PARTIAL FLOOR PLAN

LEE COMPANY, INC.
TERRE HAUTE, INDIANA

JACKSON ELEMENTARY SCHOOL
VALPARAISO, INDIANA

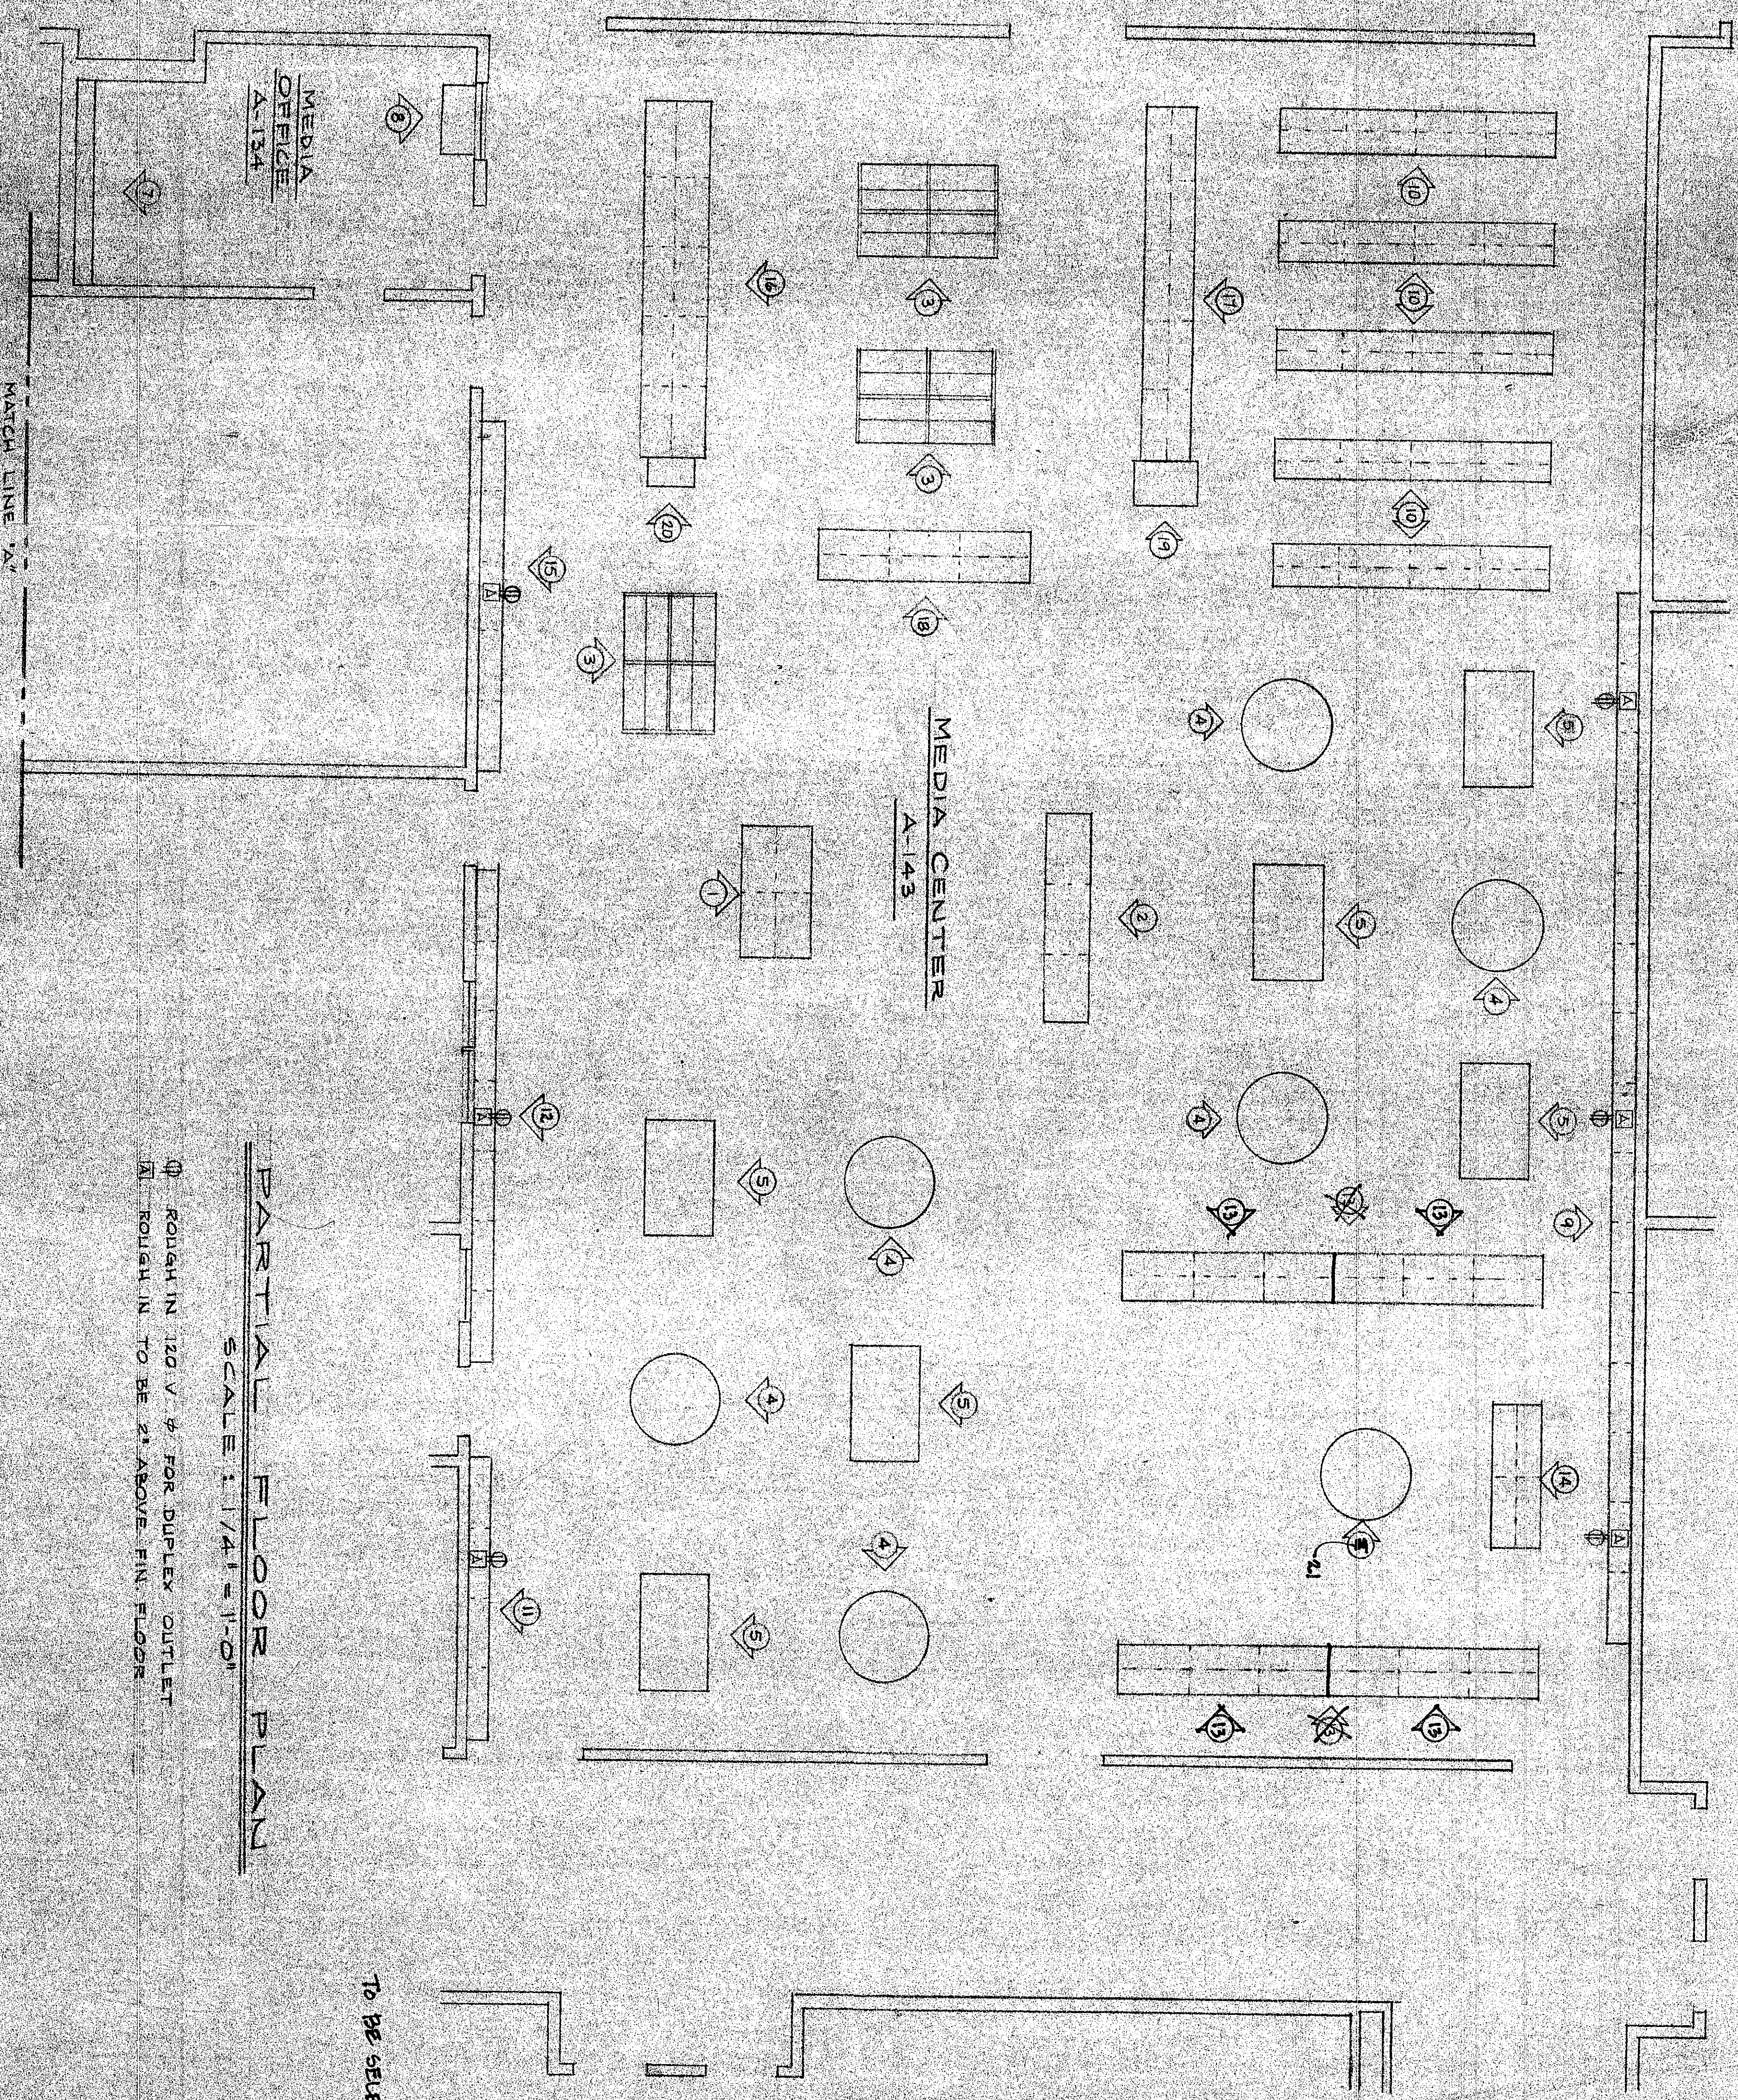
Approved As Noted
Beverly L. Brown Co.
